Access Compliance Report

Public Rights-of-Way

(Curb Ramps)

Intersection ID: N/A	Main Street: HORACE_ST	Cross Street: N/A	Location: NW
ADA ID: B63144EA7E51	Ramp Type: Directional1	Initial Pass/Fail: Fail	Overall Compliance: No
		Severity Score: 1.25

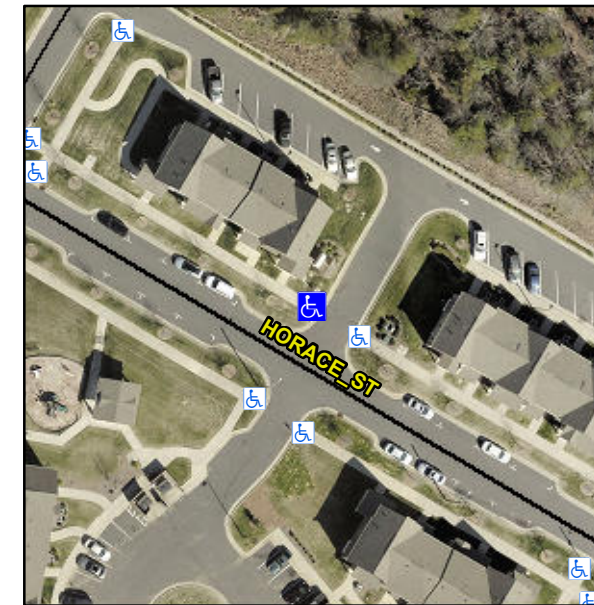
R304.5.3

Compliance	Description	Data	Compliance	Description	Data
N/A	Ramp Length (in)	24.5	N/A	Grade Break?	N/A
Yes	Ramp Width (in)	69.0	N/A	Grade Break Slope (%)	0.0
Yes	Ramp Slope (%)	3.0	N/A	Grade Break XSlope (%)	0.0
No	Ramp XSlope (%)	3.3			
N/A	Flare Type LT	N/A	N/A	Flare Type RT	N/A
N/A	Flare Slope LT (%)	N/A	N/A	Flare Slope RT (%)	0.0
N/A	Flare Traversable LT?	N/A	N/A	Flare Traversable RT?	N/A
N/A	Landing Length (in)	0.0	N/A	DWS Provided?	N/A
N/A	Landing Width (in)	0.0	N/A	DWS Contrast?	N/A
N/A	Landing Slope (%)	0.0	N/A	DWS Length (in)	N/A
N/A	Landing X Slope (%)	0.0	N/A	DWS Full Width?	N/A
N/A	Landing Curb? (Y/N)	N/A	N/A	DWS Offset LT (in)	N/A
N/A	Shared Landing?	N/A	N/A	DWS Offset RT (in)	N/A
N/A	Gutter Ponding?	0.0	N/A	Gutter Slope (%)	N/A
N/A	Gutter Lip Ht (in)	0.0	N/A	Gutter X Slope (%)	N/A
N/A	Painted X Walk1?	No		Road Slope (%)	6.5
	X Walk 1 Direction	To E		Road X Slope (%)	2.8
	X Walk 1 Width (in)	N/A		Clear Space?	N/A

Remove & Replace Entire Ramp.
